Access Compliance Report

Public Rights-of-Way

Intersection ID: 2490	Main Street: BENTGRASS_RUN_DR	Cross Street: LYLETON_LN	Location:	N
ADA ID: 02D442D261B9	Ramp Type: PerpDiag	Initial Pass/Fail: Fail	Overall Compliance: No	Severity Score: 12.5
Codes/Mitigation Info/Possible Solution		Field Measurements/Component Compliance

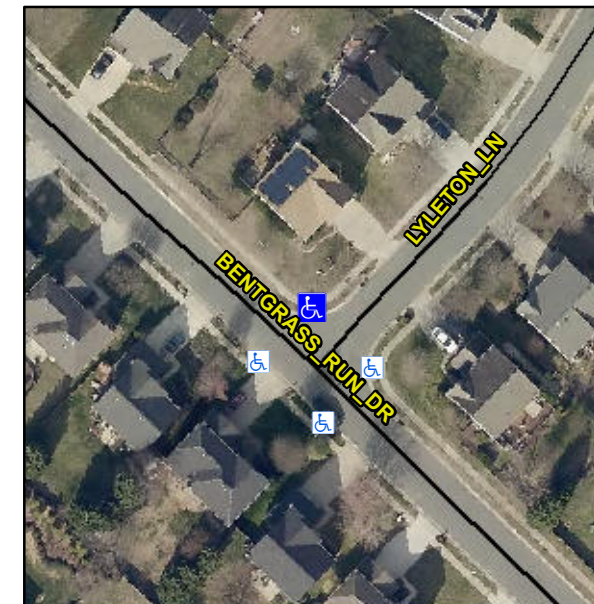
R304.2.2

Compliance	Description	Data	Compliance	Description	Data
N/A	Ramp Length (in)	45.0	No	Ramp Slope (%)	8.4
Yes	Ramp Width (in)	49.0	Yes	Ramp XSlope (%)	1.8
N/A	Flare Type LT	N/A	N/A	Flare Type RT	N/A
N/A	Flare Slope LT (%)	N/A	N/A	Flare Slope RT (%)	N/A
N/A	Flare Traversable LT?	N/A	N/A	Flare Traversable RT?	N/A
N/A	Landing Length (in)	N/A	N/A	DWS Provided?	N/A
N/A	Landing Width (in)	N/A	N/A	DWS Contrast?	N/A
N/A	Landing Slope (%)	N/A	N/A	DWS Length (in)	N/A
N/A	Landing X Slope (%)	N/A	N/A	DWS Full Width?	N/A
N/A	Landing Curb? (Y/N)	N/A	N/A	DWS Offset (in)	N/A
N/A	Shared Landing?	N/A			
N/A	Gutter Ponding?	N/A	N/A	Gutter Slope (%)	N/A
N/A	Gutter Lip Ht (in)	N/A	N/A	Gutter X Slope (%)	N/A
N/A	Painted X Walk1?	No	N/A	Painted X Walk2?	No
	X Walk 1 Direction	To SW		X Walk 2 Direction	To SE
N/A	X Walk 1 Width (in)	N/A	N/A	X Walk 2 Width (in)	N/A
	X Walk 1 Slope (%)	3.7		X Walk 2 Slope (%)	1.2
	X Walk 1 X Slope (%)	1.2		X Walk 2 X Slope (%)	4.0

Remove & Replace Curb Ramp With Two New Directional Ramps or Equivalent.
